DATE: October 20, 2019

FROM: Jack Szczepanski, Ph.D.

RE: Analysis of Transco's Responses to Public Comments on Its Waterfront Development Individual Permits (In-Water & Upland) and Coastal Wetlands Individual Permit applications for the Proposed Northeast Supply Enhancement ("NESE") Project (Program Interest #: 0000-01-1001.3; Activity #: LUP 190002)

**Figure 1**

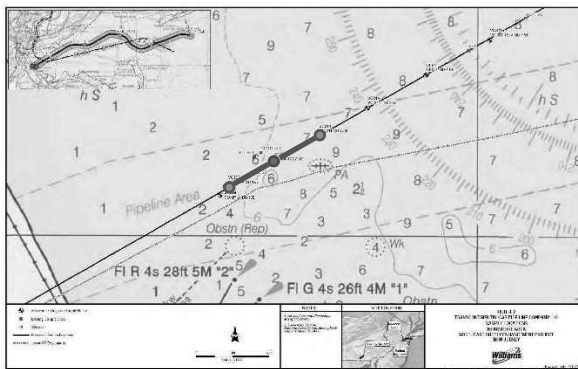
Letter to NJDEP DLUR, is a reactionary measure and there is no assurance that rate reduction will happen prior to disturbing contaminated sediment. In addition, Transco provides no explanation of how sediment contaminant levels will be monitored during trench construction to detect contaminant concentrations that would exceed water quality standards (as discussed below under Section II.E). And only 6 locations were modeled that had contaminants. These cannot be the only locations along the route that have contaminated sediments; there is, however, no testing to show the content of the areas (1) in between these 6 points and (2) between these 6 points and uncontaminated sediments. The second item concerns the uncertainty as to the extent of contamination between the uncontaminated sites and the adjacent contaminated site. For example, does the extent of contamination begin at the first recorded contaminated sediment site (VC208, Appendix F-5)? Or is there contaminated sediment immediately adjacent to where uncontaminated sites VC206 and VC211 were tested? Figures 1 and 2 below demonstrate this uncertainty respectively, with blue representing clean sediment and red representing contaminated sediment.

The extent of this contaminated sediment along the proposed route could have significant consequences for the results of the model in that contaminated sediment concentrations and resulting distribution through dredging could be higher than predicted. Transco could have done more sediment testing to confirm the accuracy of their model.
